June 28, 2018

Frank Belerique, vice president Swift River Energy Limited 300 – 60 St. Clair Avenue East Toronto, ON M4T 1N5

Re: Proposed hydro-electric generating station at the Bala falls

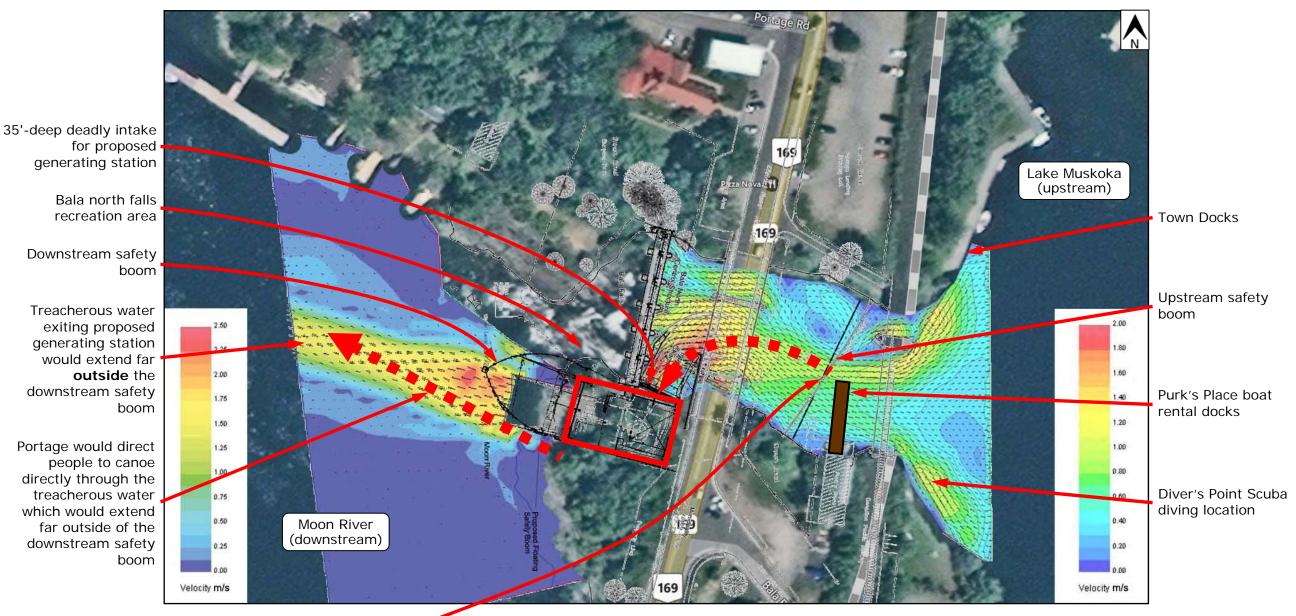
Below is a composite graphic entitled *Murdered in 45 Seconds*. This composite graphic clearly shows that the operation of the proposed hydro-electric generating station at the Bala falls would create dangerously fast and turbulent water outside of your proposed downstream safety boom.

- c) The composite graphic shows that water velocities of <u>three and even four times</u> the maximum safe water velocity of 0.5 m/s would extend <u>outside</u> of your proposed downstream safety boom.

- d) Note also that this same Plan view drawing shows the downstream end of your proposed tailrace excavation would extend past the safety boom, therefore there would be significant turbulence outside of the safety boom at this location. Turbulence is clearly a major concern as that would be what caused the 2008 drowning of a 16-year-old boy at the Wilson's Falls generating station, as he was not simply pushed downstream.
